## Release Note LS-300 VA1 v2.11.20.68

(This version is only compatible with the new HW version – VA1)

## New Features and Modification of VA1

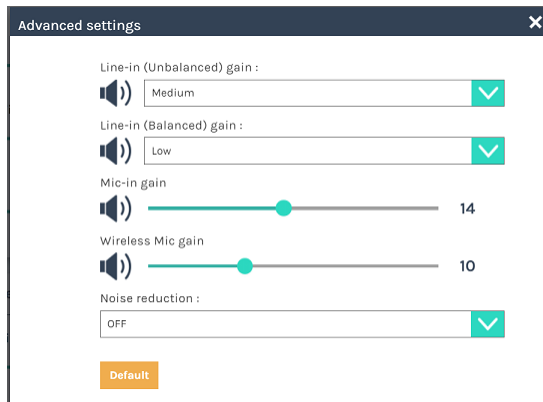
1. Differential audio input with phoenix type connector is “only” available on **LS-300**, **LS-400** and **KL-3T**.
2. Audio Noise Reduction (Line-in/Mic-in)  
It can reduce the background noise that is present in recordings.
3. Audio Gain Control (Line-in/Mic-in)  
Both balanced (Phoenix) and unbalanced (3.5mm) audio inputs have “Gain Control”.
  - Line-in (Unbalanced/Balanced): 3-step gain – Low, Medium, High
  - Mic-in/BT-Mic: 30-step gain

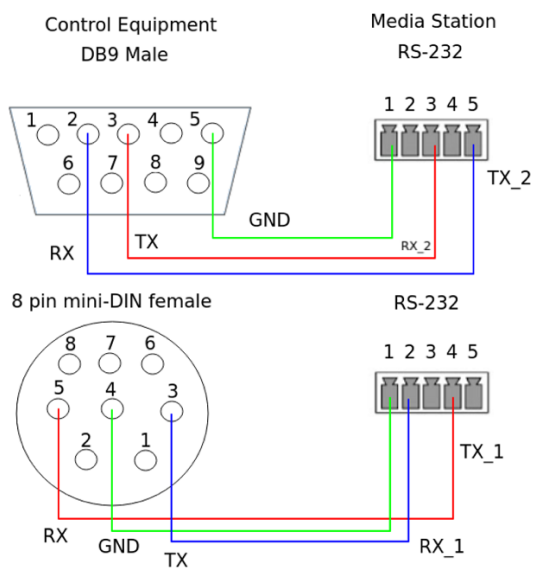
4. Equipped with one RE-232 camera control port  
The same RS-232 port can now send commands for camera control while receiving commands from control systems.  
\* It can only control one camera, for additional cameras, USB-RS-232 cables will still be needed.
